| Sheet: | F.Cu F.Silk | File: UPD-board.kicad_pcb | B.Cu B.Silk | D.Title: | Size: A4 | Date: | Rev: | KiCad E.D.A. | kicad 6.0.7-f9a2dced07-116-ubuntu20.04.1 | Id: 1/1 | Rev: | Rev:

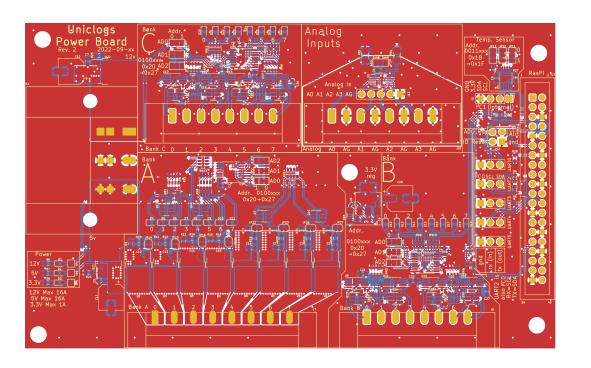
TODO:

Different analog connector Too many vias in high current traces? Different ground plane, need something special for signal ground?

Sheet:	F.Cu		
File: UPD-board.kicad_pcb		[
Title:			
Size: A4	Date:	Rev:	
KiCad E.D.A.	kicad 6.0.7-f9a2dced07~116~ubuntu20.04.1	ld: 1/1	
/1	5

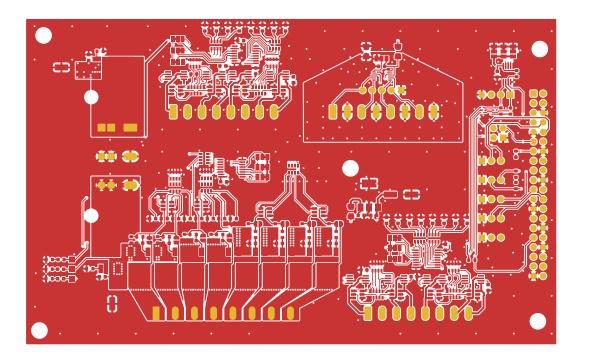
TODO:

Different analog connector Too many vias in high current traces? Different ground plane, need something special for signal ground?
